Re: Registration Certificate R-446-D-103G

I am enclosing the two illustrations you requested to complete the registration of our Model 100/4 and 100/5 timepieces.

Request for the proper drawings

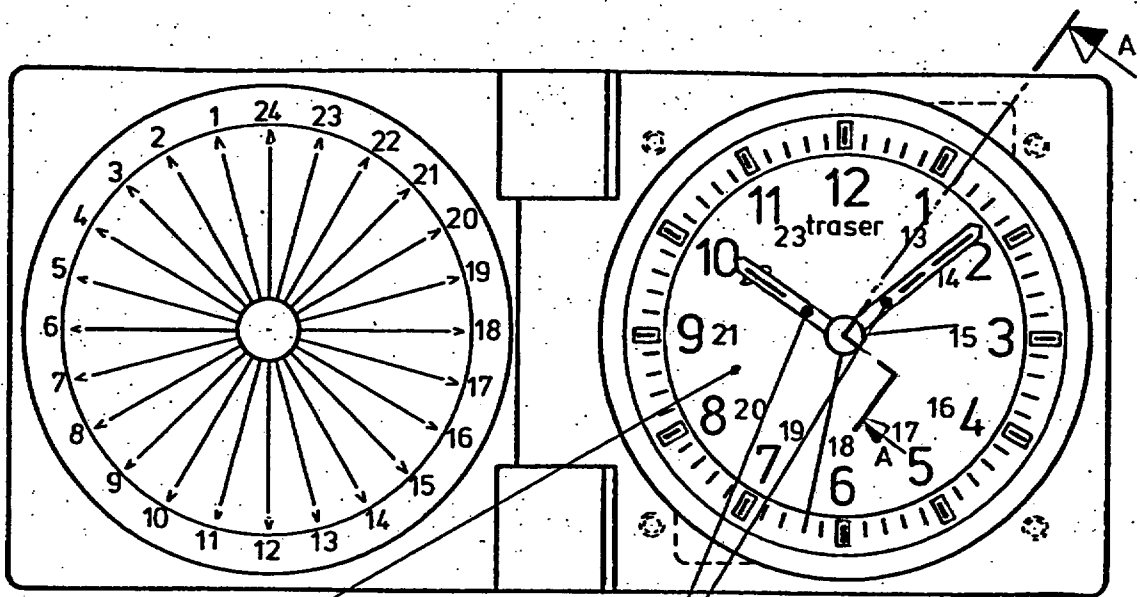
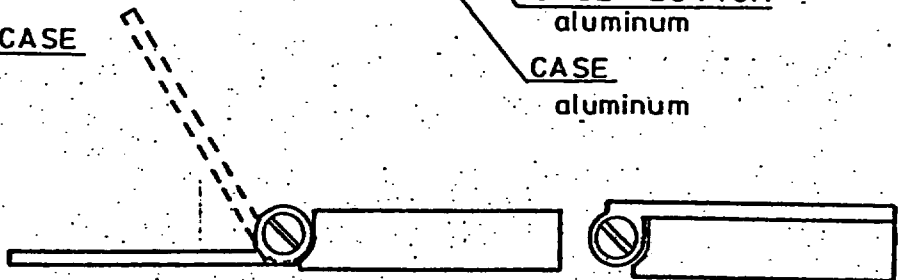
I called Mr. Keating to explain that the response to NRC's deficiency questions in his letter dated September 17, 1999, is insufficient. I discussed with him that NRC needs overview drawings for the Model Nos. 100/4 and 100/5 timepieces which show the major dimensions and components. I explained that the drawings should be similar to those of the other models which are listed in the certificate. Mr. Keating said that he will provide the drawings as soon as he can.
